THE ROVER COMPANY LIMITED
SERVICE DEPARTMENT

Rover Service News Letter No. 49

October 29th, 1954

Fig. 1. Length of swivel pin. ~~1948-53~~
1954-55

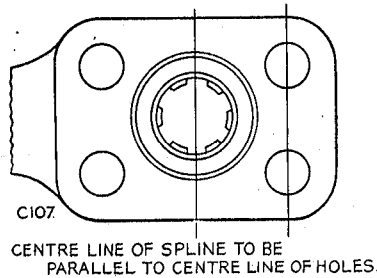
1. Front half shaft.
1948-53 Half shaft, tracta joint and stub shaft are all separate items.
1954-55 Half shaft, universal joint and stub shaft are connected up as one assembly.
2. Bearing for half shaft.
1948-53 Ball } External dimensions are identical.
1954-55 Roller }
3. Swivel pin and steering lever.
Effective length of swivel pin as shown below:—

Fig. 4. Housing for swivel pin bearing. 1948-53.

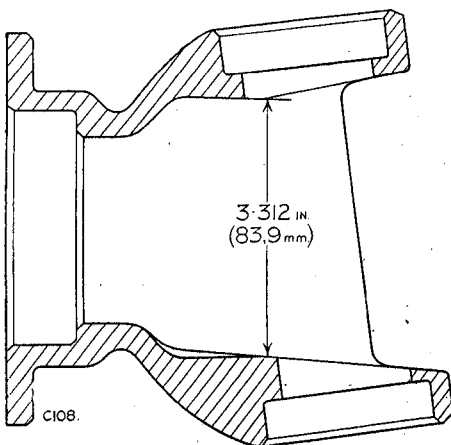
4. Housing for swivel pin bearing.
Internal dimension as detailed below:—

Fig. 8. Position of oil hole.
1948-53.

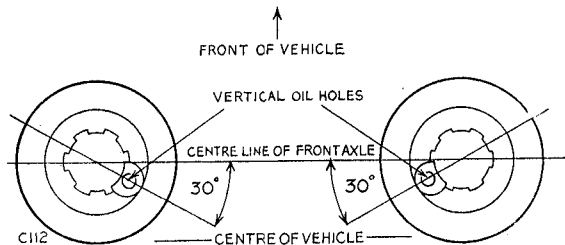
In the assembly of the cone bearing and the steering lever the **relationship of the oil hole in the cone bearing to the centre line of the front axle** is very important. The sketch below illustrates the position of the oil hole for the models concerned.
